Technical Service Bulletin (TSB)
Right Side Door Trim Panels Not Secure

REFERENCE:	TSB: 23-045-24 GROUP: 23 - Body	Date:	June 14, 2024	REVISION:	-
VEHICLES AFFECTED:	2024 (WL) Grand Cherokee / Grand Cherokee L This bulletin applies to vehicles built on or after February 22, 2024 (MDH 0222XX) and on or before May 06, 2024 (MDH 0506XX).			MARKET APPLICABILITY:	
				<input checked="" type="checkbox"/> NA	<input type="checkbox"/> MEA
				<input type="checkbox"/> SA	<input type="checkbox"/> IAP
				<input type="checkbox"/> EE	<input type="checkbox"/> CH
CUSTOMER SYMPTOM:	Customers may experience one or more of the following: <ul style="list-style-type: none"> Both right door trim panels loose. Both right door panels rattles during music. 				
CAUSE:	Incorrect torque applied

Fig. 1
Door Trim Interior Handle

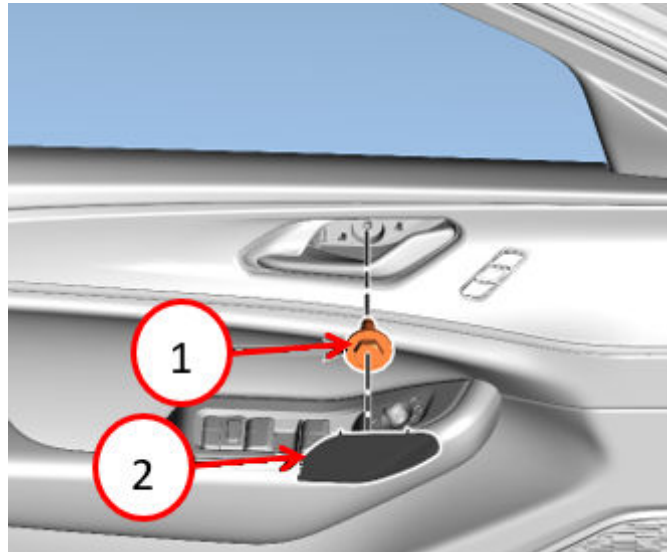
Using a small flat bladed tool or equivalent, pull out on the interior right door handle and remove the trim cover located in the door handle cavity [Fig. 1](#).

3. Verify trim bolts [Fig. 1](#) and [Fig. 2](#) are tightened to 8 N·m (71 In. Lbs.).
4. After trim bolts are tightened, place door trim panel screw covers back on.

Fig. 2
Pull Cup Trim

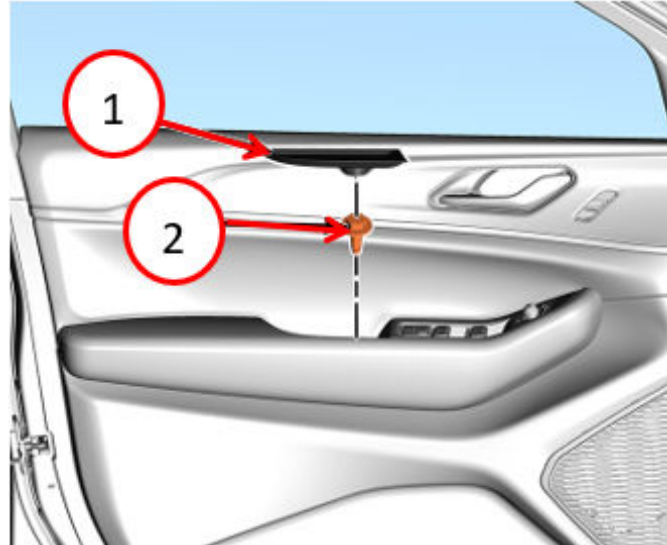
2. Using a small flat bladed tool or equivalent, remove the right pull cup trim mat [Fig. 2](#).
